[Docket No. FAA–2009–1253; Directorate Identifier 2009–NM–080–AD; Amendment 39–16629; AD 2011–06–05]

Airworthiness Directives; The Boeing Company Model 737–600, –700, –700C, –800, –900, and –900ER Series Airplanes

ACTION: Final rule.

2011–06–05 The Boeing Company: Amendment 39–16629. Docket No. FAA–2009–1253; Directorate Identifier 2009–NM–080–AD.

Figure 1

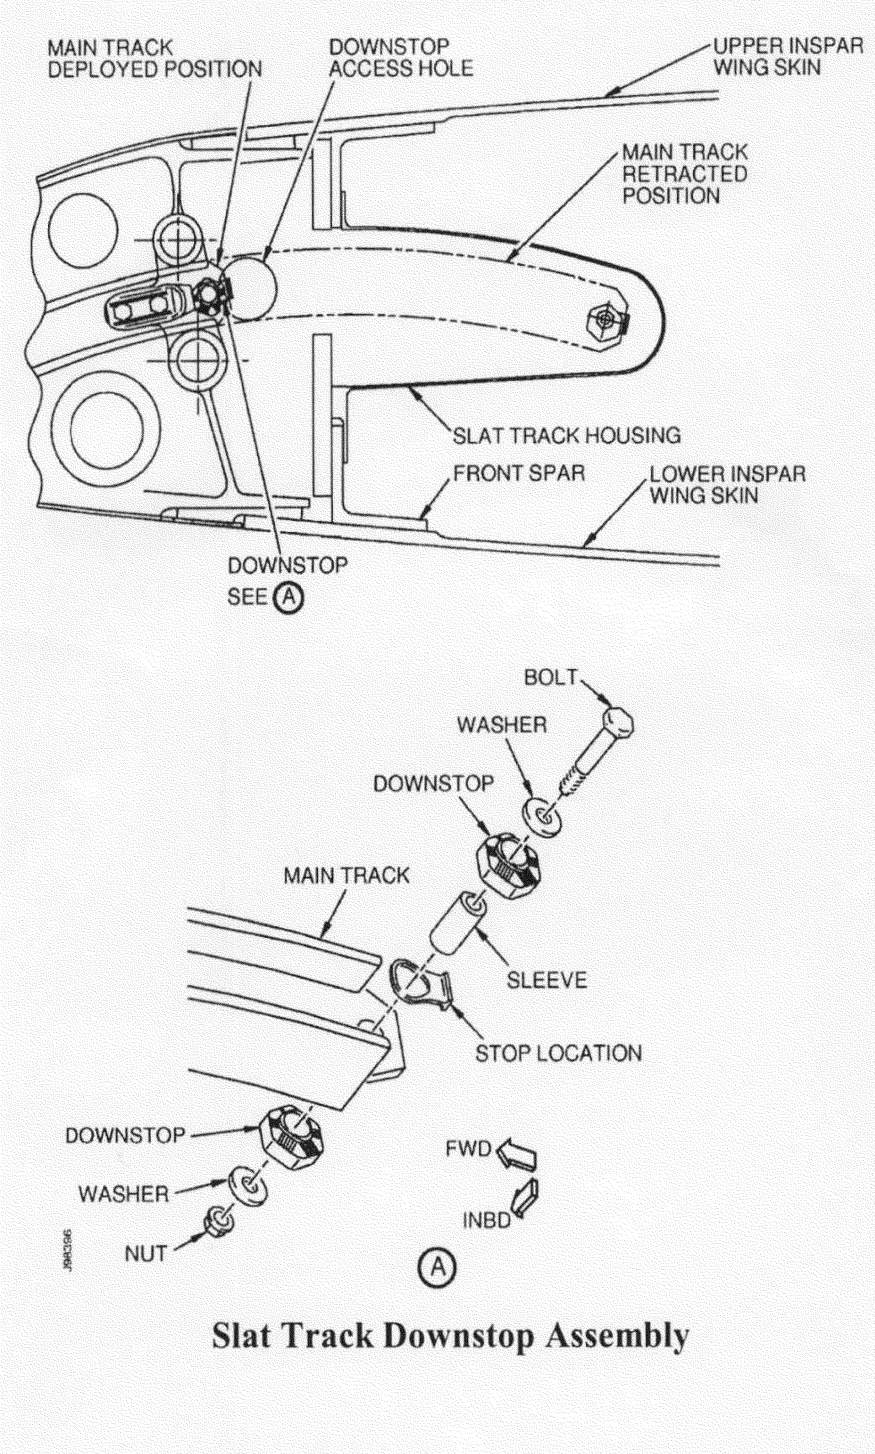
(g) Within 10 days after September 26, 2007 (the effective date of AD 2007–18–52): Do a detailed inspection or a borescope inspection of each main slat track downstop assembly to verify proper installation of the slat track hardware (*i.e.,* the bolt, washers, downstops, stop location, and nut shown in Figure 1 of Boeing Service Letter 737–SL–57–084–B, dated July 10, 2007, and in this AD). Proper installation of the sleeve need not be confirmed, and the stop location part may be installed on either the inboard or the outboard side of the slat track. If any part is missing or is installed improperly, before further flight, install a new or serviceable part using a method approved in accordance with the procedures specified in paragraph (j) of this AD; and do a detailed inspection of the inside of the slat can for foreign object debris (FOD) and damage. Before further flight, remove any FOD found and repair any damage found using a method approved in accordance with the procedures specified in paragraph (j) of this AD. Verify proper installation; install a new or serviceable part; and inspect for damage and FOD, and remove FOD and repair damage; in accordance with a method by approved by the Manager, Seattle Aircraft Certification Office, FAA; or in accordance with Boeing Multi Operator Message Number 1–523812011–1, issued August 25, 2007, or 1–527463441–1, issued August 28, 2007. Repeat the actions required by paragraph (g) of this AD thereafter at intervals not to exceed 3,000 flight cycles.
